Project	IEEE 802.16 Broadband Wireless Access Working Group < http://ieee802.org/16 >	
Title	Supplemental material for Tgd comments	
Date Submitted	2004-04-25	
Source(s)	Itzik Kitroser Yossi Segal Yigal Leiba Zion Hadad Runcom Technologies Ltd. 2 Hachoma St. 75655 Rishon Lezion, Israel	Voice: +972-3-9528440 Fax: +972-3-9528805 mailto:itzikk@runcom.co.il mailto:yossis@runcom.co.il mailto:yigall@runcom.co.il mailto:zionh@runcom.co.il
Re:	802.16-REVd Sponsor ballot recirc	
Abstract	This document contains supplemental material for 802.16-REVd sponsor ballot	
Purpose	Adopt suggested changes into P802.16-REVd/D4 draft	
Notice	This document has been prepared to assist IEEE 802.16. It is offered as a basis for discussion and is not binding on the contributing individual(s) or organization(s). The material in this document is subject to change in form and content after further study. The contributor(s) reserve(s) the right to add, amend or withdraw material contained herein.

Supplemental material for Tgd comments

This contribution provides specific text changes instructions as a supplemental text for 802.16-REVd sponsor ballot. Editorial instruction is indicated by a **red bold** text wit

Figure 209—Example of the data region which defines the OFDMA allocation

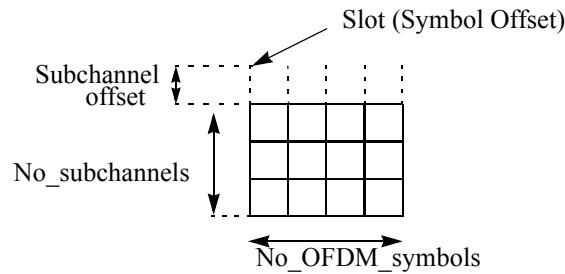
Comment #257. The current OFDMA PHY contain usage of concepts as Zone and a Segment which are not clearly defined anywhere. A clear definition of the terms is required for a consistency reasons. In addition the OFDMA data mapping referes to FEC block, while the correct term is OFDMA slot.

A slot in the OFDMA PHY requires both a time and subchannel dimension for completeness (subchannels are defined in 8.4.6.). An OFDMA slot is one subchannel by ~~two~~one OFDMA symbol.

In OFDMA, a Data Region is a two-dimensional allocation of a group of contiguous subchannels, in a group of contiguous OFDMA symbols. This allocation may be visualized as a rectangle, such as the 4x3 rectangle shown in Figure 209.

Figure 213—Time plan - one TDD time frame (with only mandatory zone)

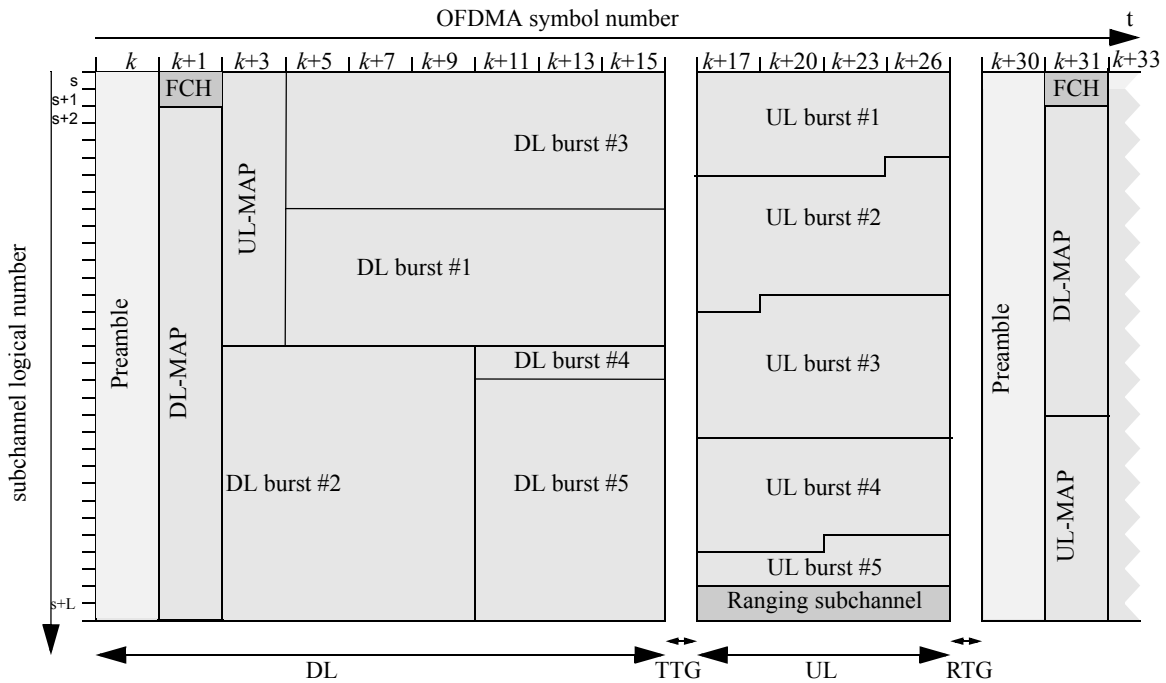
Comment #350 changed the UL allocating scheme to a uni-dimensional scheme. This means that the UL allocations are no longer rectangles, this should be reflected in figure 213. In addition figure 213 does not provide a clear example of the OFDMA frame with multiple zones.

[Page 468, line 5, section 8.4.4.2, change figure 213 (and title) as follows:]

Figure 215—FCH subchannel allocation for all 3 segments

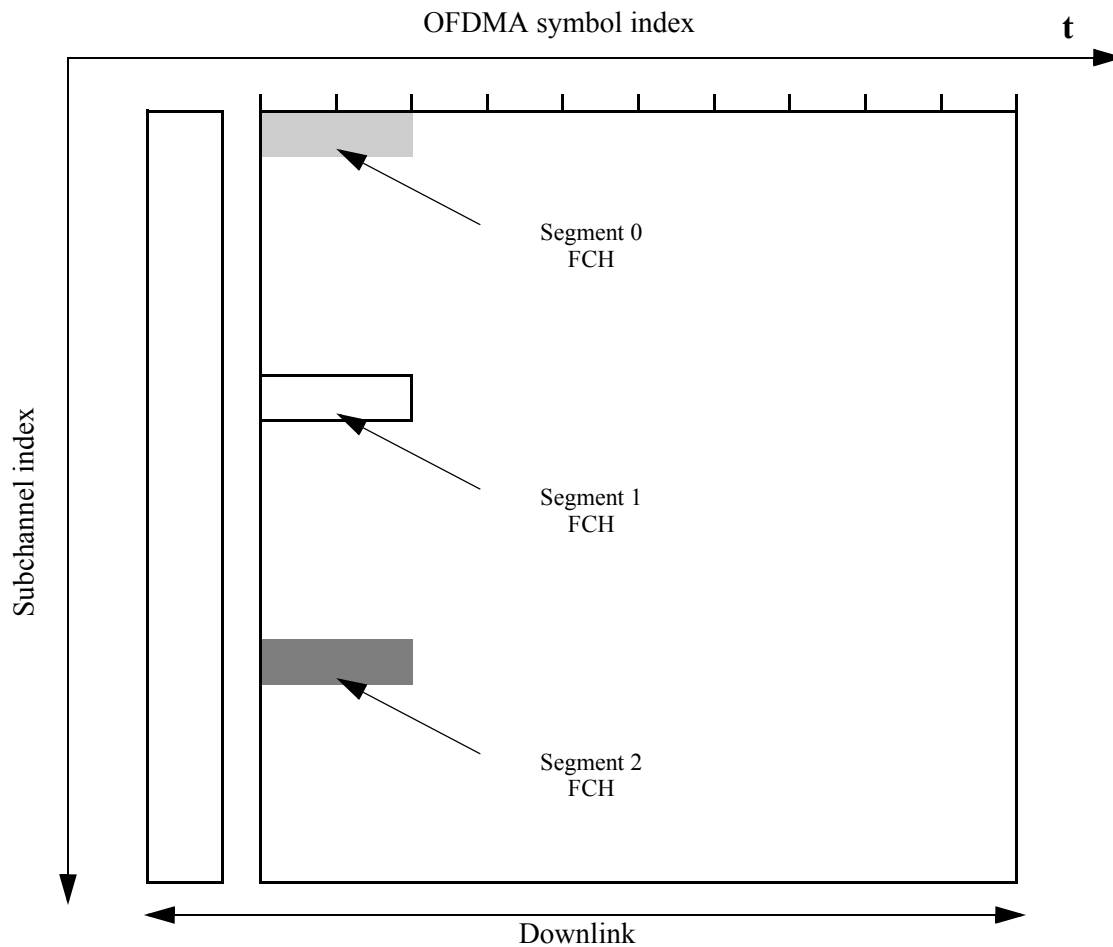
In addition, figure 215 describes the FCH as transmitted over one OFDMA symbol and two subchannels, and should be two OFDMA symbols over one subchannel.

[Page 471, line 4, section 8.4.4.5, replace figure 215 with the following figure]

Figure 216—Example of renumbering the allocated subchannels for segment 1 in PUSC

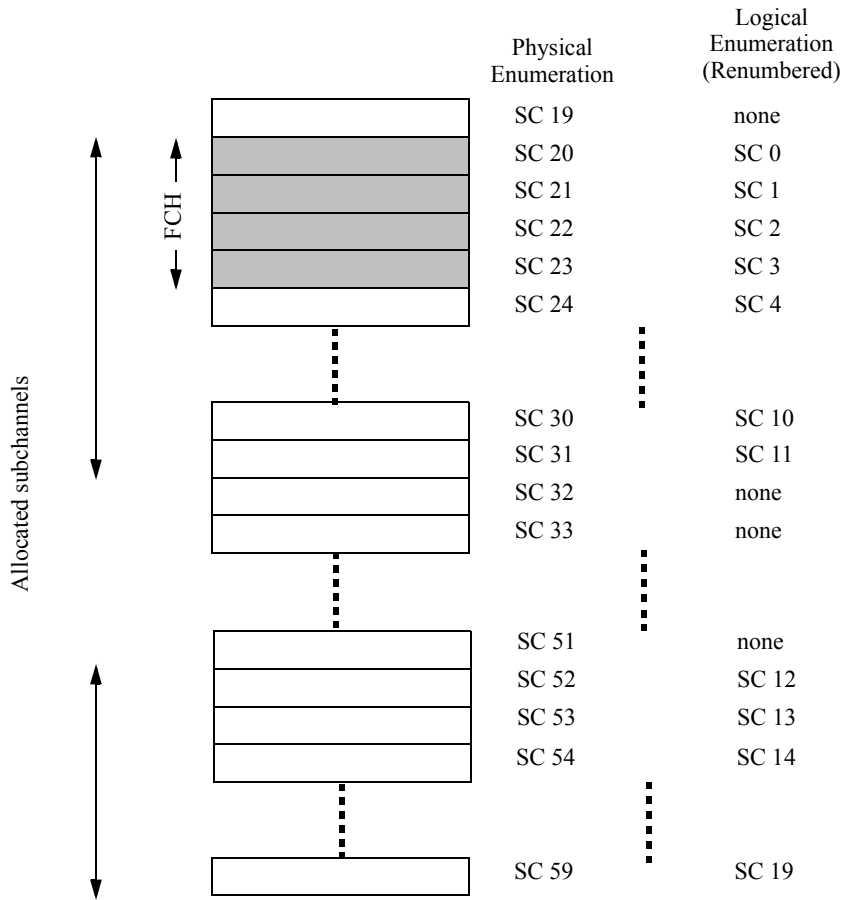
The example given in figure 216 is wrong, since the standard defines that the FCH is transmitted using a duration of 4 OFDMA subchannels.

[Page 472, line 2, section 8.4.4.5, Change figure 216]

Figure 217—Example of UL renumbering the allocated subchannels for a segment in PUSC

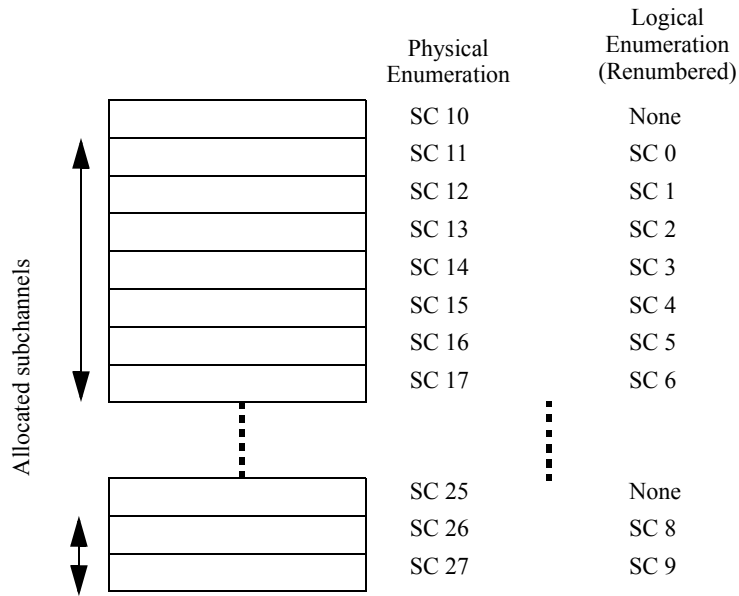
The current subchannels renumbering definition for the UL stating that "no renumeration is done" is wrong, since obviously a renumbering scheme is required.

[Page 472, line 2, section 8.4.4.5, Insert new figure 217]

Figure 235— STC usage with OFDMA for FUSC

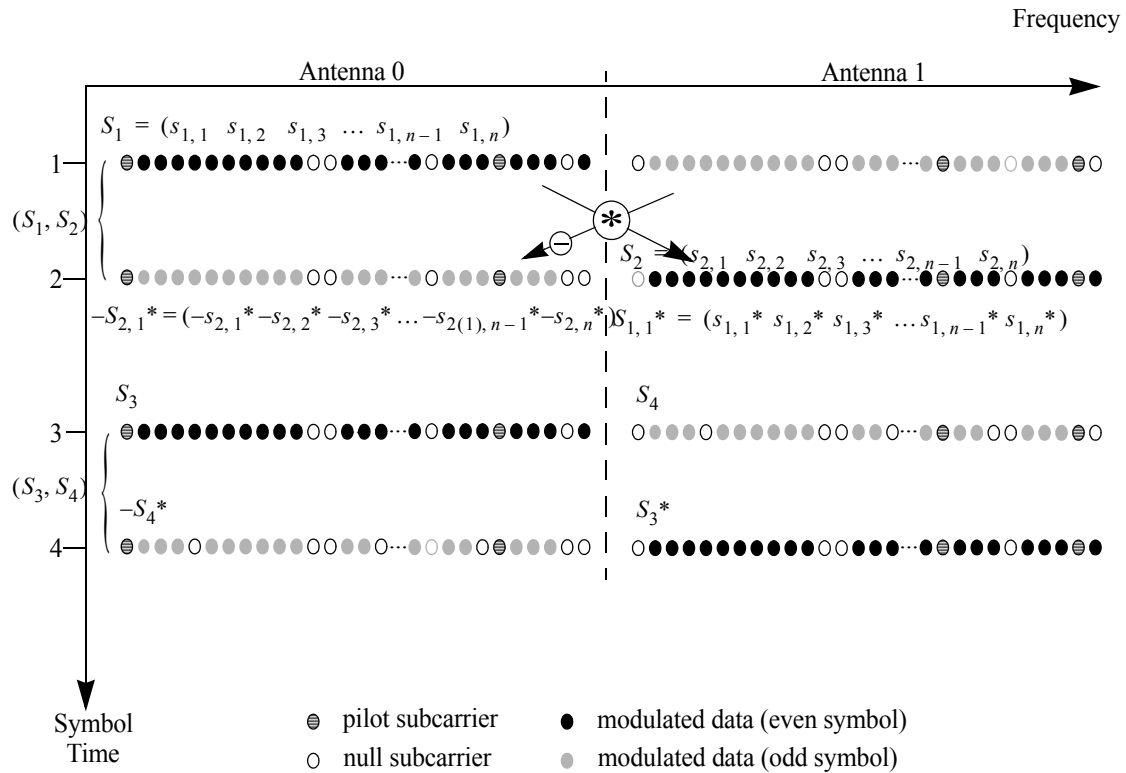
Comment #362 contained instruction to change figure 235, this comment wasn't implemented due to an unclear instruction, this comment provide the required changes. In addition, the existing figure is relevant for FUSC only, an additional figure is required for the PUSC case.

[Page 519, line 3, section 8.4.8.2.1, change figure 235 as indicated, change title to make figure relevant to FUSC]
